# TECHNICAL INFORMATION

- Subject** ▶ Modifications of Flat Washer 37 and Tool Holder
- For Models** ▶ HM1202, HM1202C, HM1242C
- Country** ▶ All countries
- Description** ▶ For further improvement in hammering action;  
1) Flat Washer 37 has been made thicker and harder.  
2) The groove on Tool Holder that holds Ring Spring 34 has been made deeper.

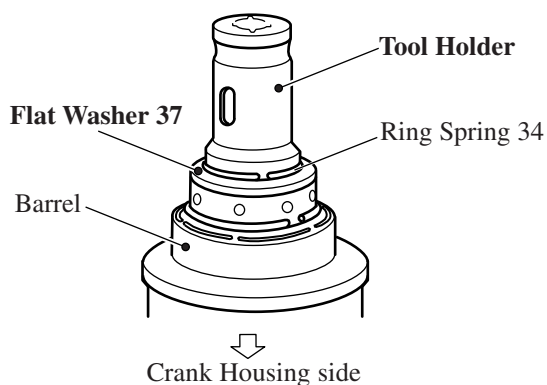
▶ Current	▶ New
[Cross section]	
2.0mm	2.2mm

▶ Current	▶ New
[Cross section]	
<p>ø35.0mm</p> <p>Crane Housing side</p>	<p>ø34.8mm</p> <p>The groove for Ring Spring 34 has been made deeper by 0.1mm.</p>
